**CERTIFICATE OF APPROPRIATENESS**

**Applicant:** Alexander Ridgeway, Brickmoon Design for Todd and Denise Liebl, owner

**Property:** 501 Highland Street, lot 16, block 9, Woodland Heights Subdivision. The property includes a historic 1,654 square foot two story residence and two story garage-apartment situated on a 5,000 square foot (50' x 100') interior lot.

**Proposal:** Alteration – Addition

**SOUTH ELEVATION – FRONT FACING HIGHLAND STREET**

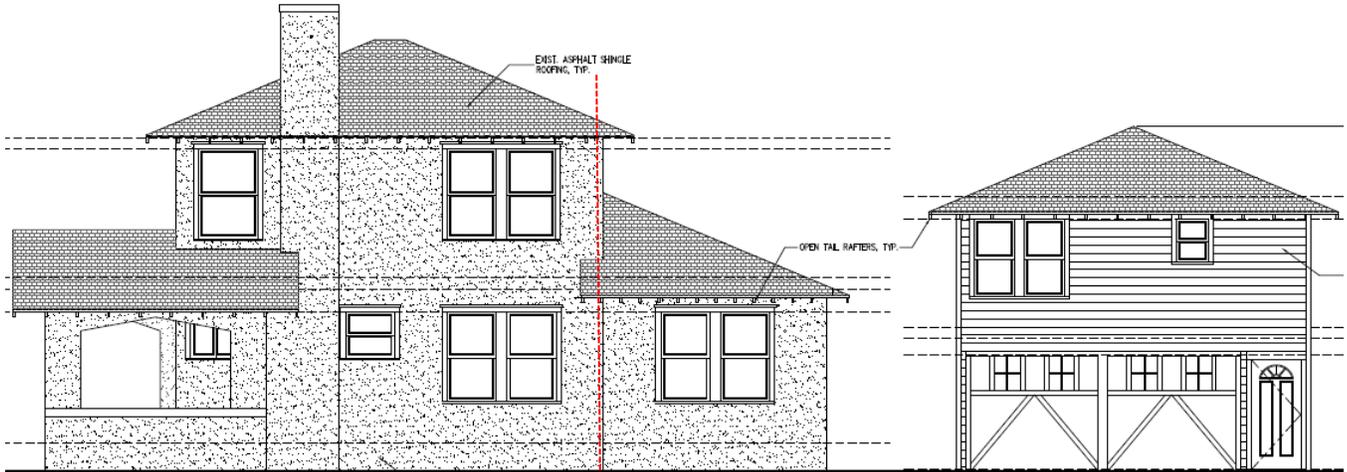
**Front Elevation:** Lift the existing residence 11" and install 4 front facing crawlspace vents. Replace all of the existing stucco with new stucco of matching texture and finish. The front existing concrete steps with three risers will be replaced with new concrete steps with 4 risers to compensate for the added height. The addition will extend 12' wider than the existing original residence and will feature a craftsman style door.

- **Inset the addition 1' from the existing structure along the east elevation. This would reduce the visibility of the addition from the street, visually delineate it from the existing residence, and comply with applicable deed restrictions. There is space at the northwest corner of the lot that could accommodate the space lost from inseting the addition along the east side.**
- **Leave the existing residence at its existing finished floor height. This would eliminate the need to modify or remove elements of the structure that are not easily moved, including the chimney and the front porch.**

EAST SIDE ELEVATION FACING HELEN STREET

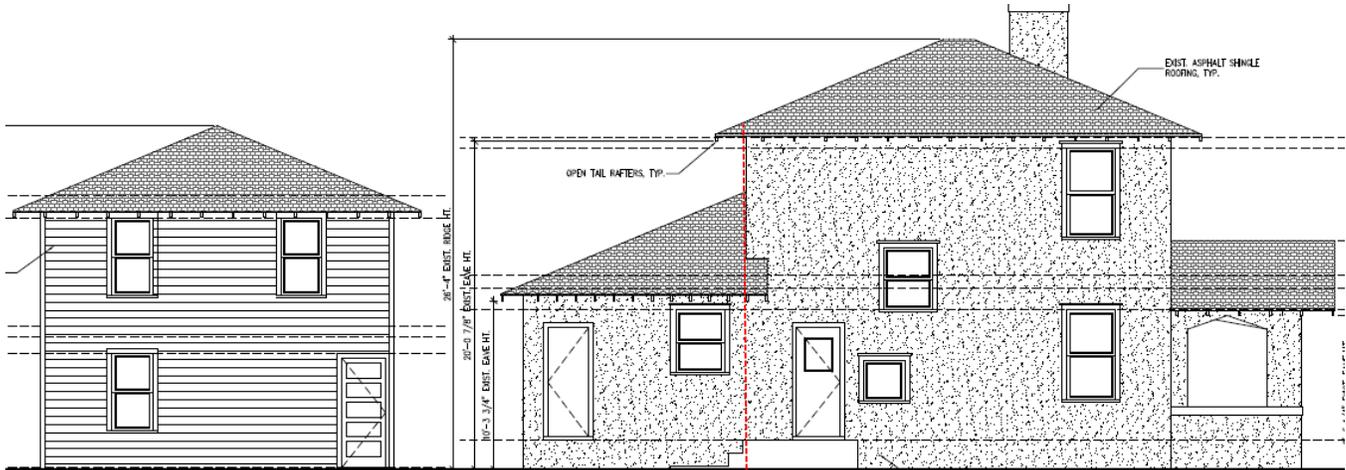
- (10) The setback of any proposed construction or alteration must be compatible with existing setbacks along the blockface and facing blockface(s);
- (11) The proposed activity will comply with any applicable deed restrictions.  
*The proposed east facing setback appears to violate Woodland Height's deed restrictions. The matter is being reviewed by Legal.*

**Side Elevation:** Lift the existing residence 11" and install 7 crawlspace vents. Replace all of the existing stucco with new stucco of matching texture and finish. The addition will begin at the rear wall of the original structure or 25' 11" from the front wall of the existing structure. This will necessitate removing an existing one story non-original rear addition. The addition will feature two windows on the first floor and three on the second. The addition will extend 21' 5" towards the rear of the property and connect with the existing side facing garage-apartment. The garage's existing 105 cladding will be removed and replaced with stucco matching the residence and the addition. The garage will feature new wood garage doors on the first floor a pair of windows on the second and a juliet balcony.

WEST SIDE ELEVATION

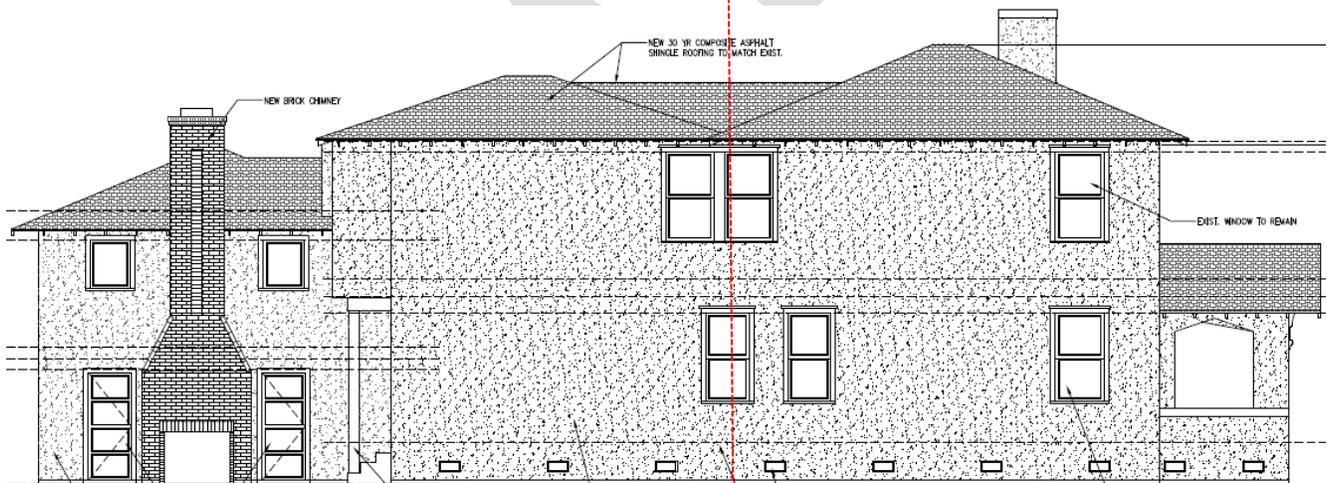
**Side Elevation:** Lift the existing residence 11" and install 7 crawlspace vents. Replace all of the existing stucco with new stucco of matching texture and finish. Remove an existing single lite window next to the existing side door and a 1-over-1 windows between the first and second floors. These openings will be covered with stucco cladding. Remove the existing non-original side door and replace with a new window. The addition will extend 21' 7" towards the rear of the property.

**NORTH (REAR) ELEVATION**

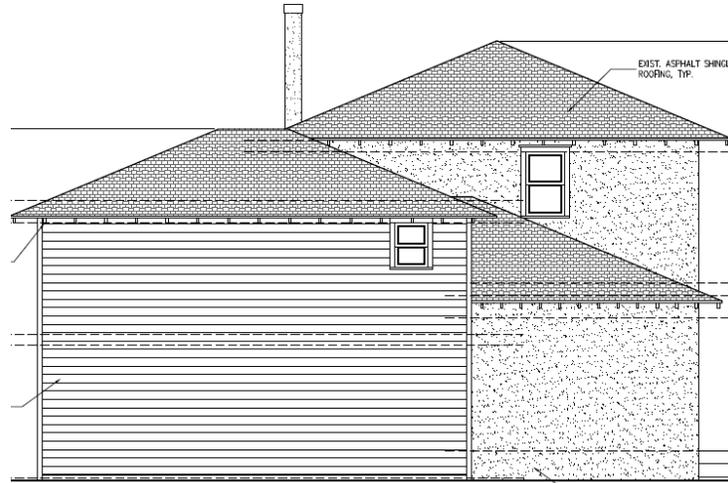
**Rear Elevation:** Remove the existing 105 siding from the existing garage-apartment and replace with stucco. Install a north facing shed roofed pop up in the existing hipped roof structure.

EXISTING PHOTO SHOWING SHIPLAP REMOVED WITHOUT A PERMIT

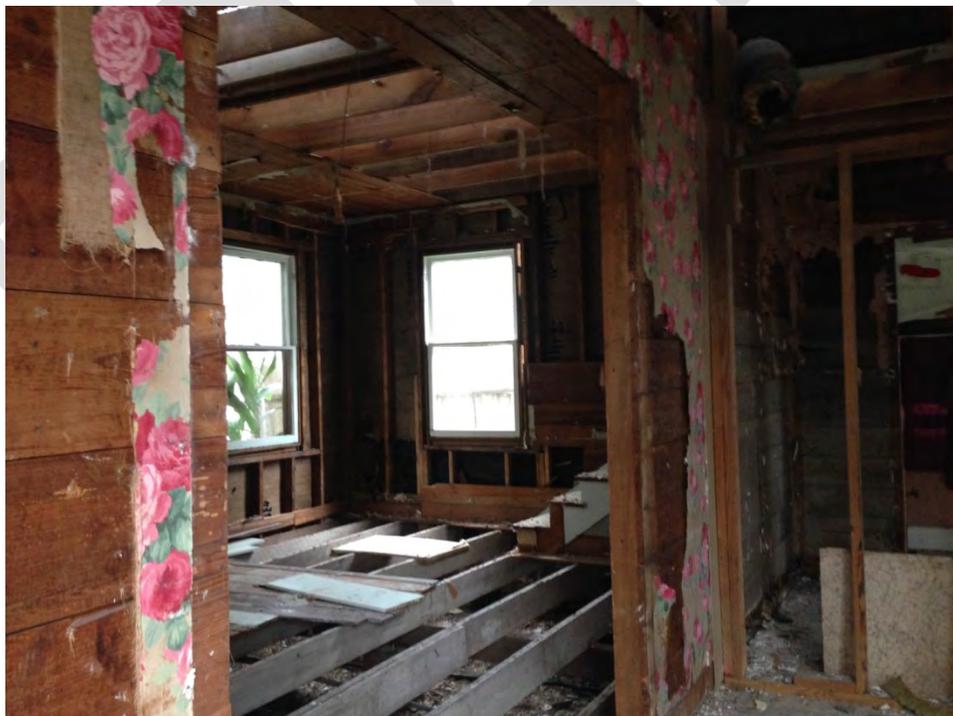
- Remove the existing residence's structural wall material. During a site visit, staff noted that the applicant had exceeded a permit to remove interior finishes by removing all of the historic shiplap. The applicant asserts that the removal of the shiplap was not intended and was the result of the demolition crew exceeding their instructions.

- (8) Proposed additions or alterations must be done in a manner that, if removed in the future, would leave unimpaired the essential form and integrity of the building, structure, object or site;  
*The proposed lifting of the residence risks damaging or significantly altering the existing front porch and chimney. These features often need to be rebuilt as part of a structure being raised. The house's original structural shiplap has been removed and destroyed.*
